HISTORIC AND DESIGN REVIEW COMMISSION

July 01, 2015

HDRC CASE NO: 2015-261
ADDRESS: 201 E GRAYSON ST
LEGAL DESCRIPTION: NCB 975 BLK 18 LOT 11, 12 & 13
ZONING: C3 RIO-2
CITY COUNCIL DIST.: 1
APPLICANT: Jonathan Card/Urbanist Design
OWNER: Gray Street Partners
TYPE OF WORK: Exterior modifications

01 CANOPY DETAIL
SCALE: 1/2" = 1'-0"

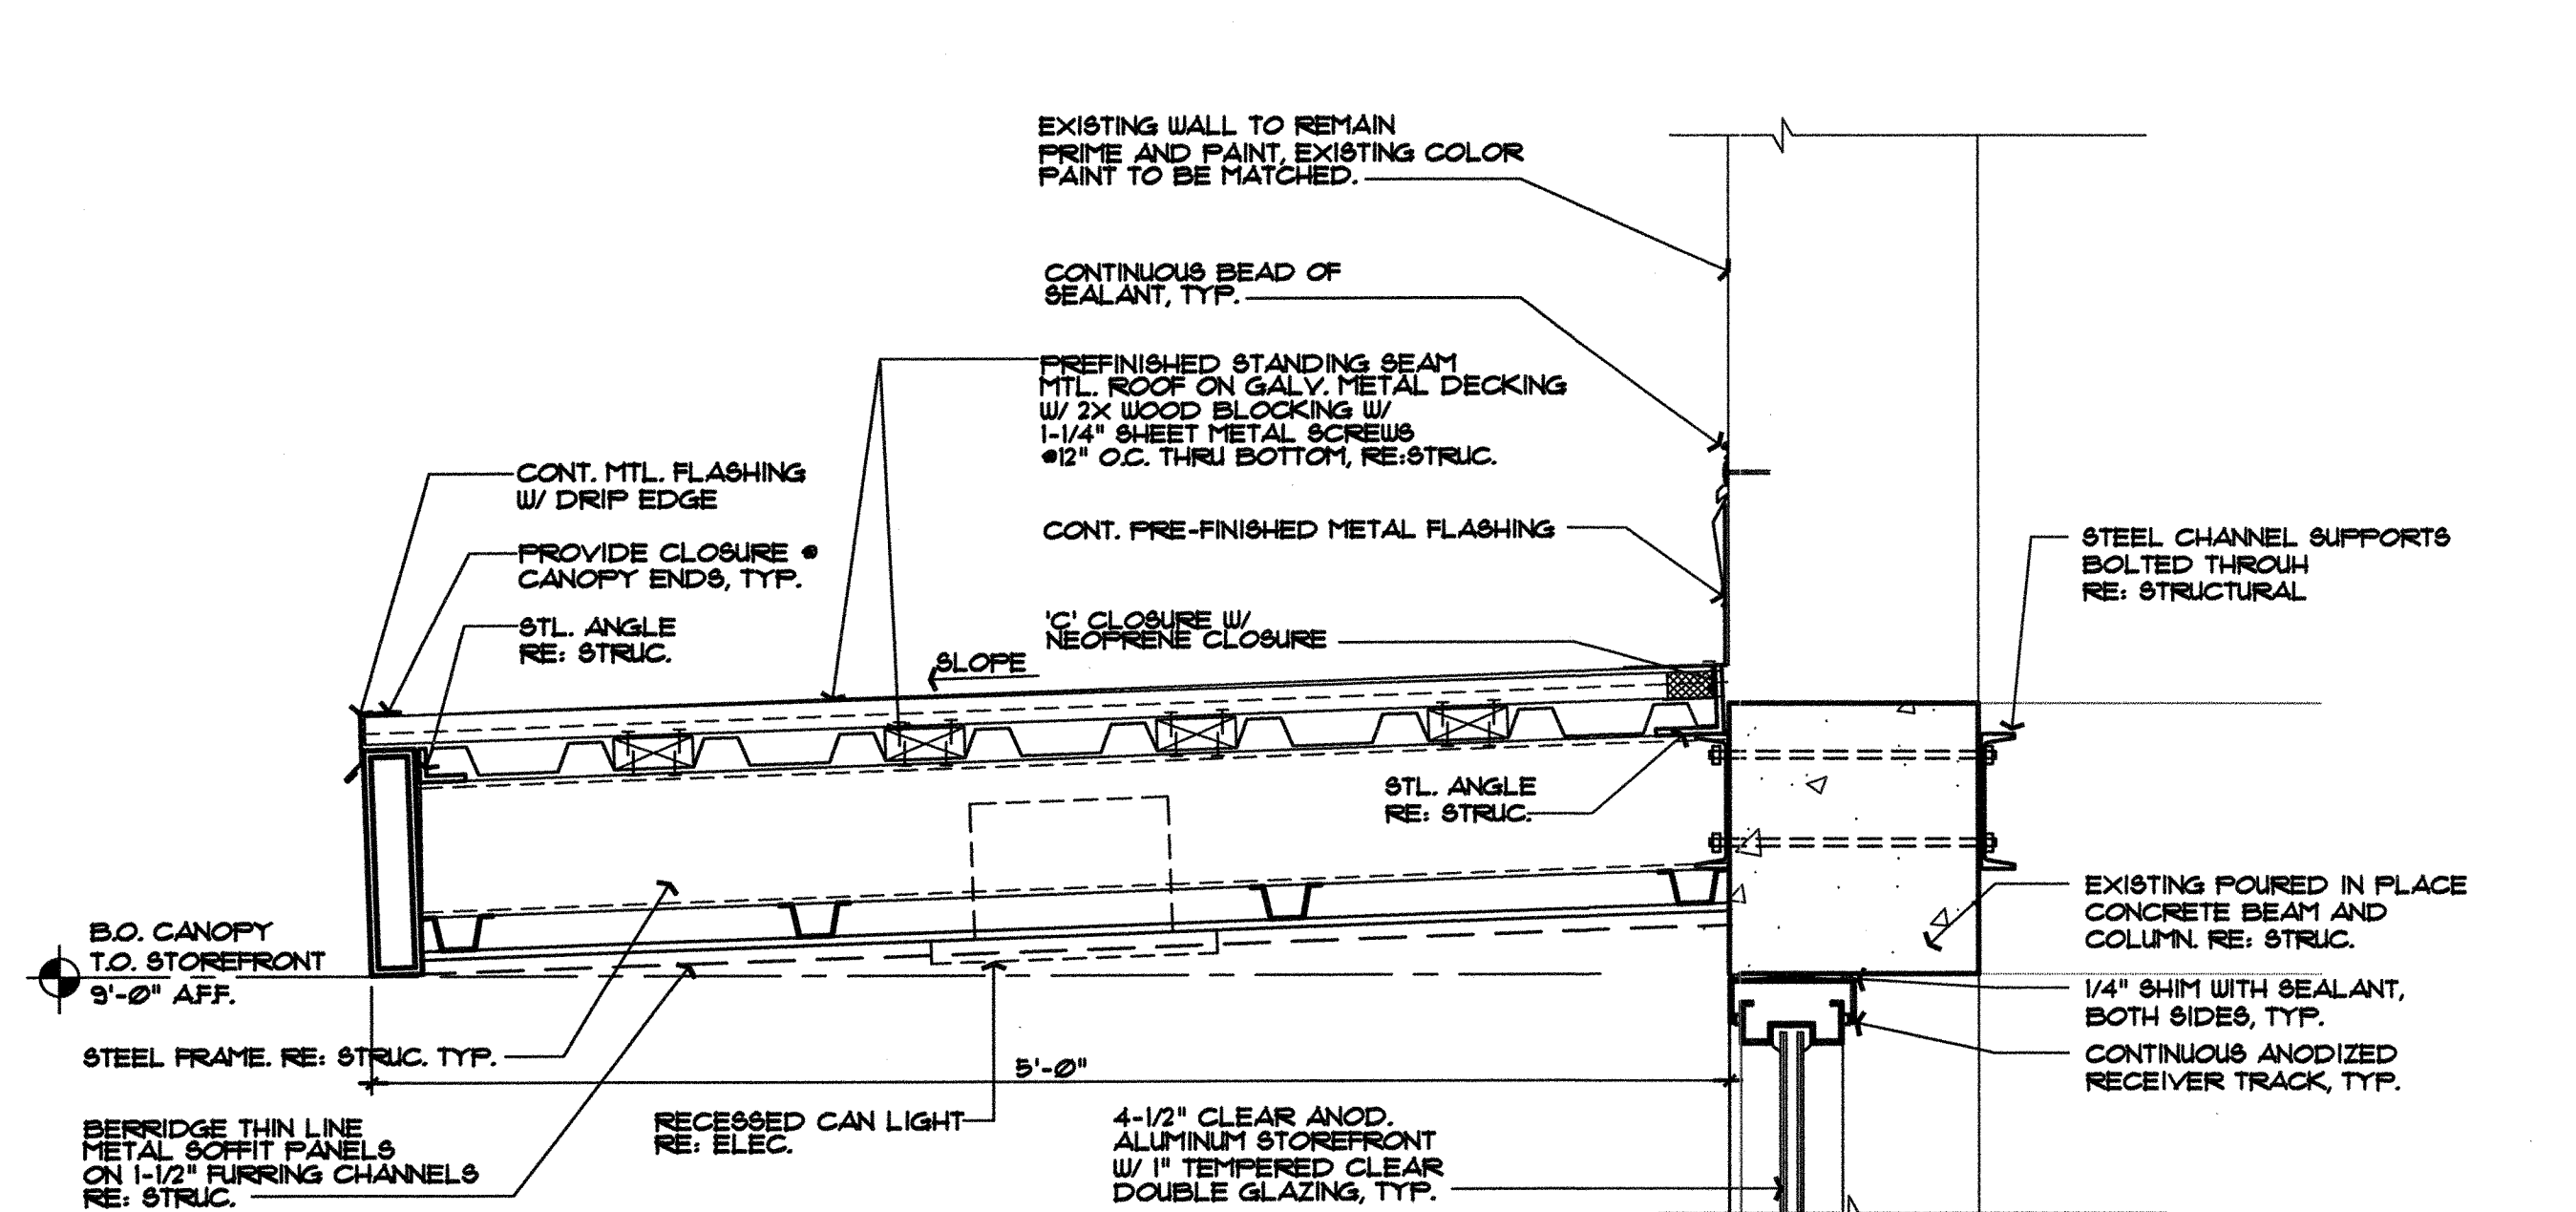
- k. According to the UDC Section 35-674(g), awnings, arcades and canopies should accentuate the character defining features of a building, should be constructed of metal, wood or fabric, should contain a color that is coordinated with that of the building. The applicant has proposed awnings that complement elements of the existing structure in both material and color. This is consistent with the UDC.

05 TILE AND MTL. PANEL DETAIL
SCALE: 3/4" = 1'-0"

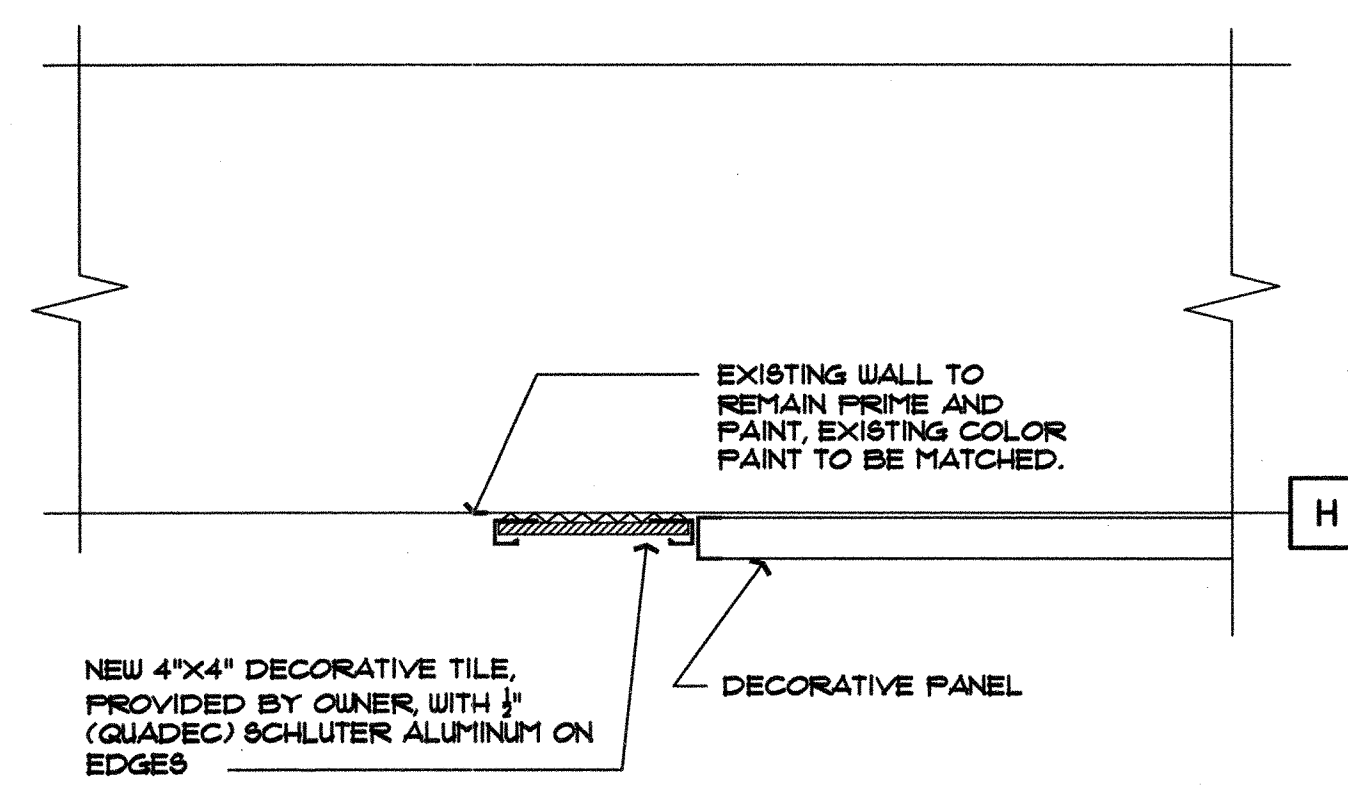
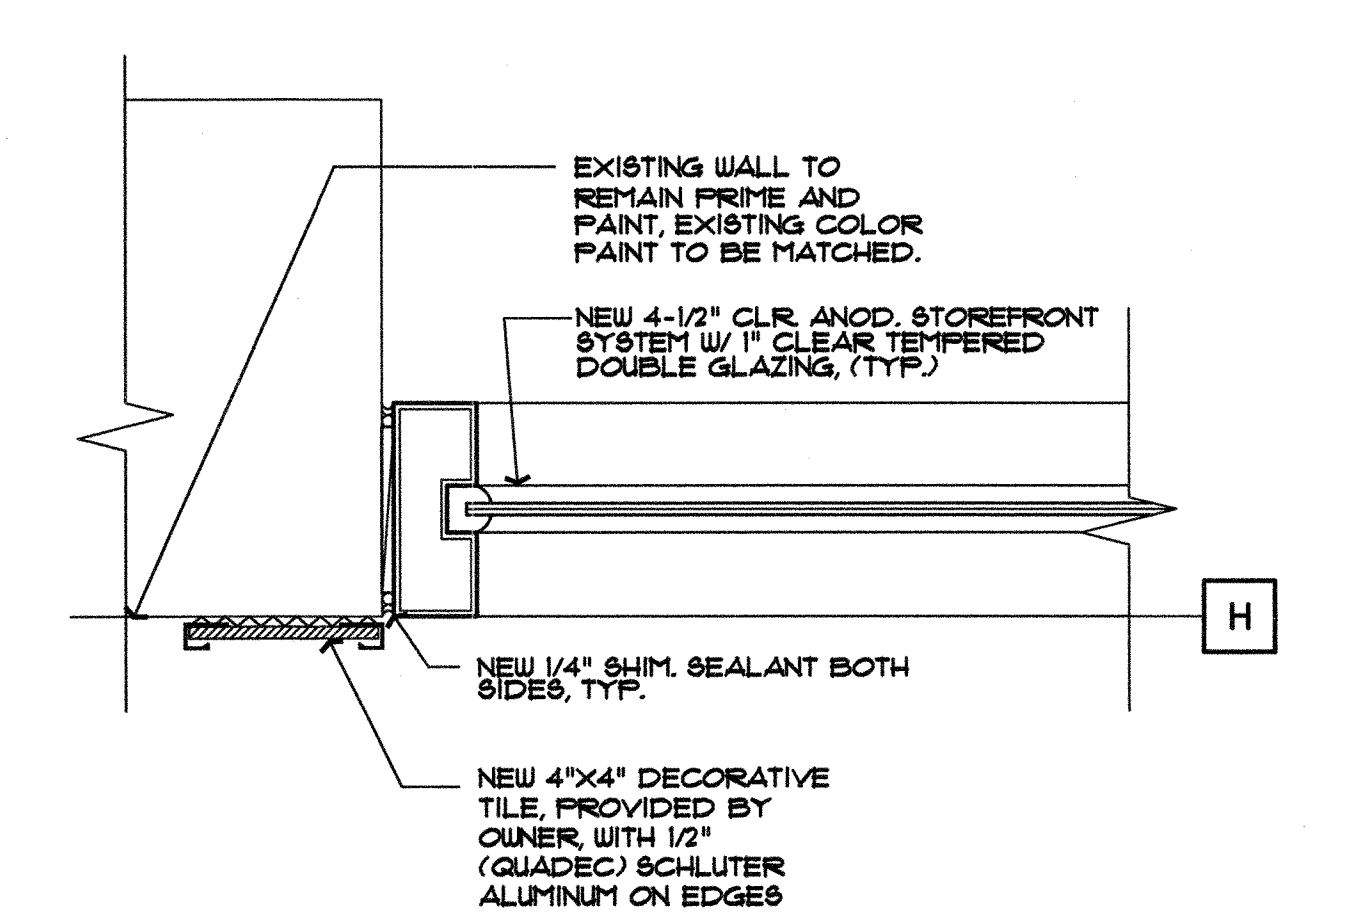
- g. Along with various minor repairs, the applicant has proposed to repair the exterior wall by patching any holes and restoring and repainting the existing tile work. This proposal is consistent with the UDC Section 35-676(i).

- j. The applicant has proposed a small area of decorative metal panels to include two decorative steel fans that are be attached to the steel frame. The applicant's proposals are consistent with the UDC Section 35-674(d)(1) and (2).
